Smiley Road Reconstruction

Driveway and Entrance Evaluations

Prepared for

City of Bridgeton, Missouri
11955 Natural Bridge Rd.
Bridgeton, MO 63044

FIGURE A: TYPICAL DRIVEWAY SECTION

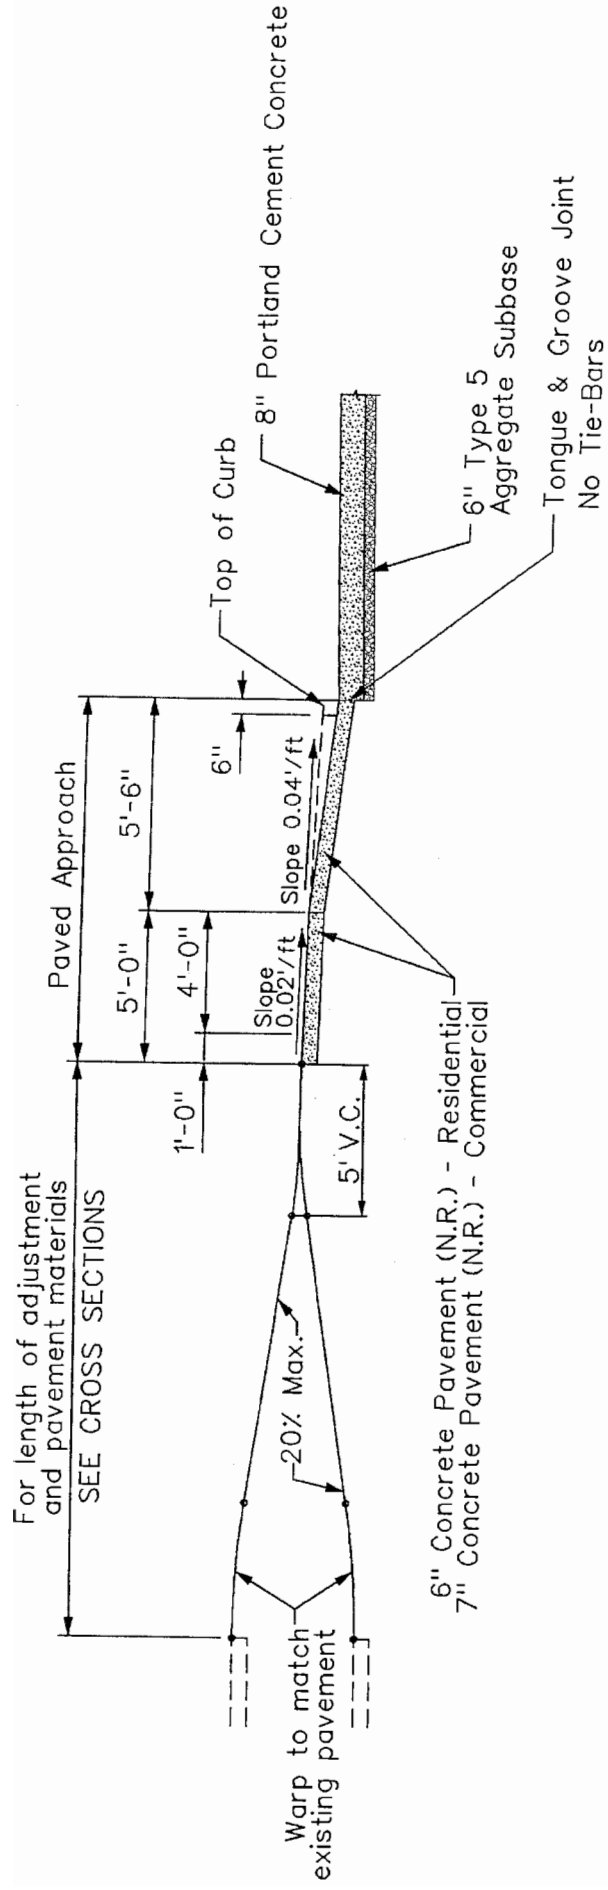
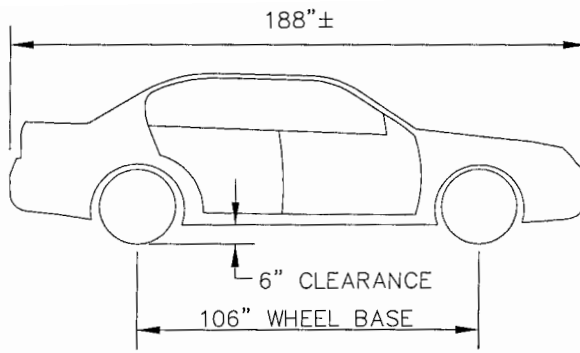
Driveways: We also concur that the driveways were designed in accordance with the St. Louis County Standards, with a qualification. St. Louis County's standard detail indicates a "desired maximum grade of 15%" (15-feet of rise or fall for every 100' of driveway length). The reason for the word "desired" is to allow for flexibility that is often times needed in isolated circumstances to make a project work. In the Smiley Road Plans, the entrance / driveway detail indicates a "maximum" grade of 20%. Given the extreme differences in elevation and the several relatively steep drives that existed prior to construction, it is our opinion that the establishment of 20% as a limit is reasonable.

Generally, it is easier to accommodate a steeper grade on a driveway that goes up from the street than for a drive that goes down. The Smiley Road Plans are consistent with that. The steepest design grades on the driveways are on the west side, on "up" drives, while the "down" drives on the east are limited to a maximum design grade of -15% as recommended in the County's detail. There is, however, a slight ambiguity in the plans. The driveway detail includes a vertical curve at each end of the new pavement, one that begins at the sidewalk and a second one at the end where it meets the existing driveway pavement, see Figure A. These curves are intended to temper the severity of a grade break, and they are most important on "down" drives, as they provide additional ground clearance. The driveway sections, which were prepared individually for each driveway and provide the details used to establish the specific drive elevations, did not include the vertical curves. The contractor was required to make the interpretation and warp them in the field. Vertical curves are not needed in many cases, so it is not uncommon for plans to be prepared this way. However, not having them shown in the individual driveway sections provides an easy opportunity for the drives to be constructed without them.

FIGURE B: DRIVEWAY SECTION W/OUT VERT. CURVE

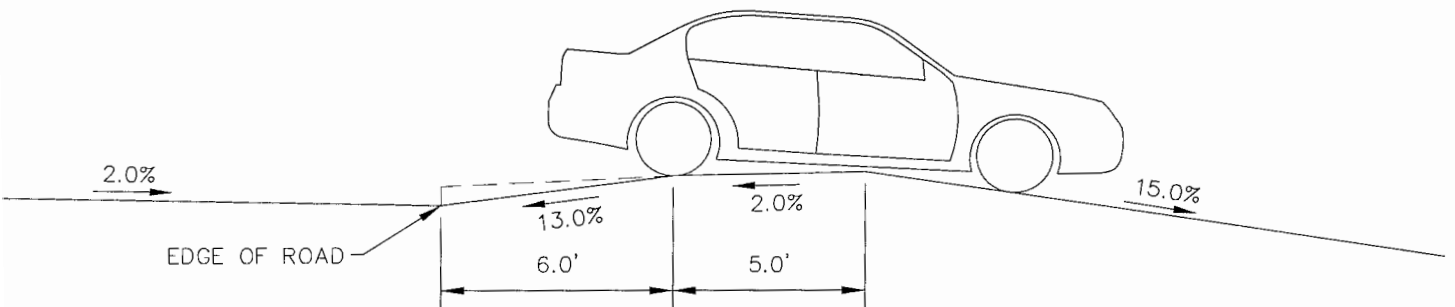
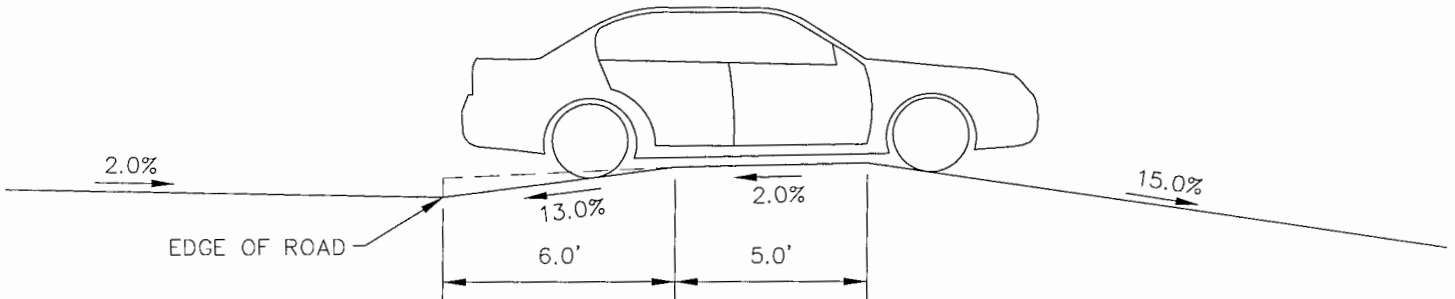
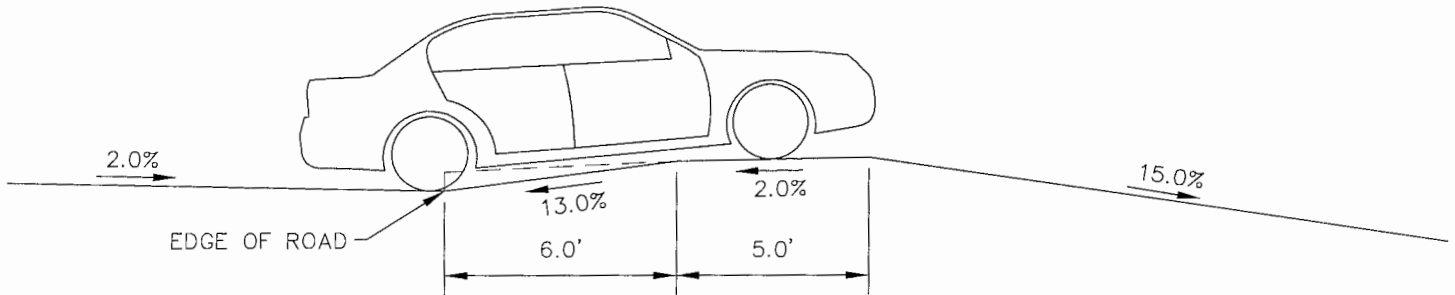
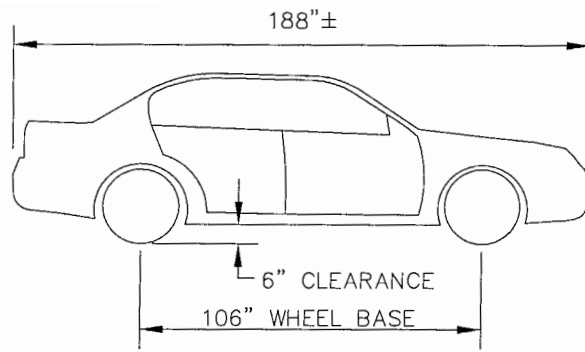
As noted above, the vertical curve is most important on "down" driveways and, while it is good practice to include them at points where the down grade will be steeper than 4%, they are much more important when the down grade exceeds -10%, see Figure B. They are not as important on the "up" driveways, due to the up angle of the car as it crosses the walk and continues up, see Figure C for illustration.

It is our opinion that all drives currently function adequately for an average passenger vehicle. The four drives noted above, however, would benefit from a vertical curve beginning at the back of sidewalk. Figures B & C depict a 2008 Chevrolet Malibu passing through the maximum “up” and “down” conditions as measured and observed in the field.
